Field Safety Notice

21st May 2018 – FSN 1

Product: Peek Acuity Pro App

Product	Product Code	Software Version
Peek Acuity Pro App	PV_PAC_001	3.5.2

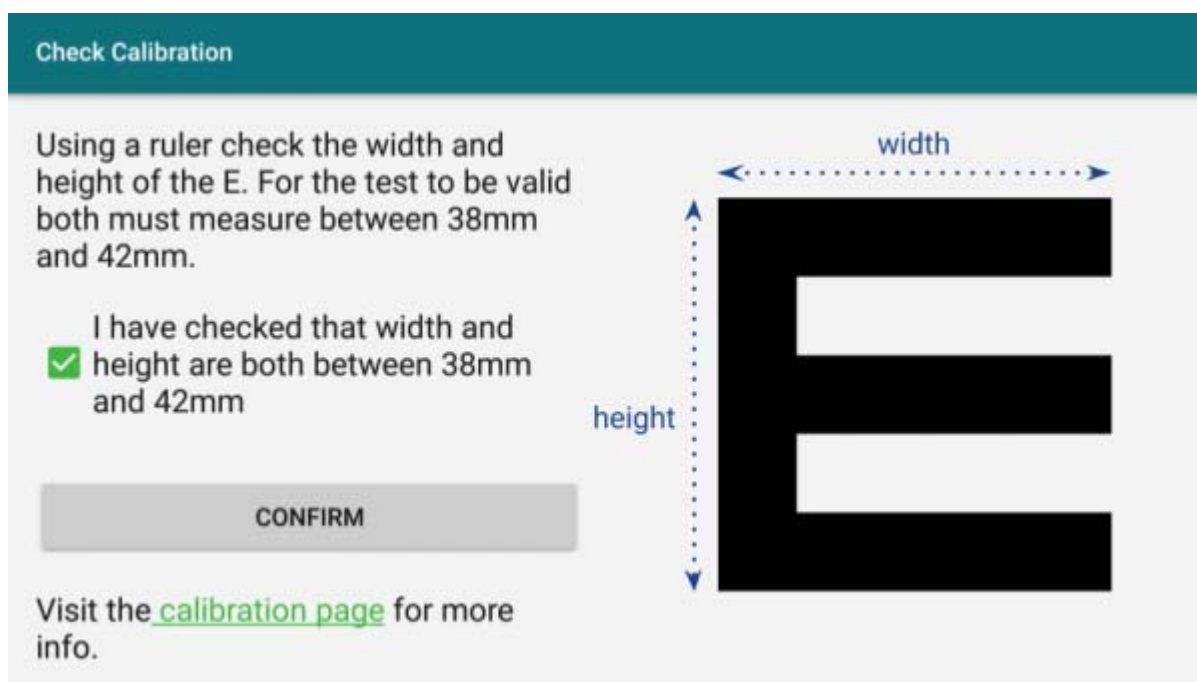
The calibration check should pop up automatically once you've updated the app. If it doesn't appear automatically, or if you want to perform calibration more than once, go to the Settings menu in the app, and select Check Calibration:

As described above, Peek Vision has released an update to Peek Acuity Pro (3.5.13) that enforces the users to perform a calibration step to identify if their device is functioning correctly by using a ruler or measuring tape to confirm the size of "E" generated by the test.

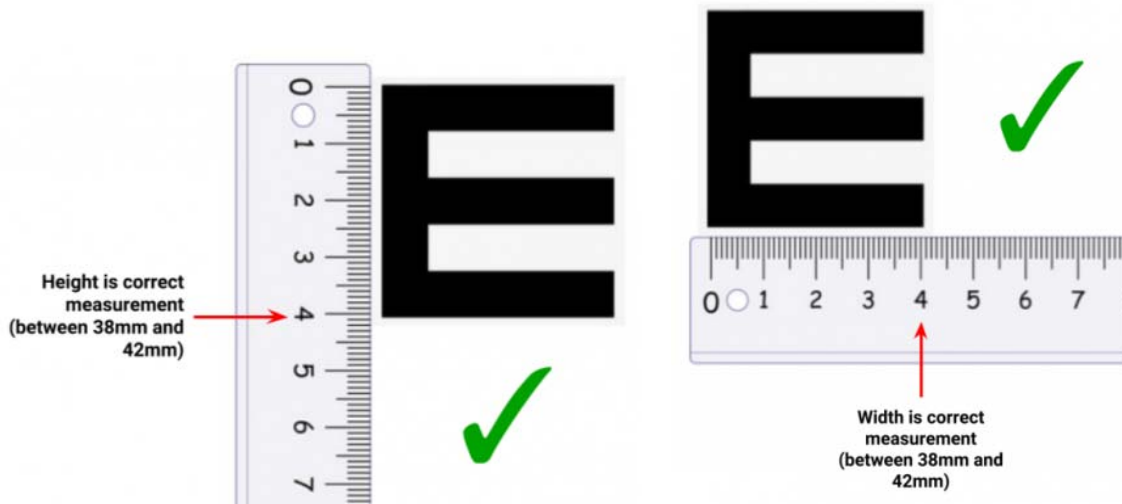
When the calibration window opens, you'll be prompted to measure the width and height of the "E" symbol:

Using a ruler or measuring tape, measure the dimensions of the E symbol as shown here:

If both width and height measurements are correct, check the box to confirm that both width and height are correct, and then you can continue to use Peek Acuity with confidence that the results will be at least as accurate as [conventional vision charts](#).

If either or both measurements are not between 38mm and 42mm, please do not use your device to conduct Peek Acuity vision checks, as the results will be inaccurate. If you use any other apps which rely on accurate measurement (e.g. a "ruler" app), you may find that accuracy is similarly affected.
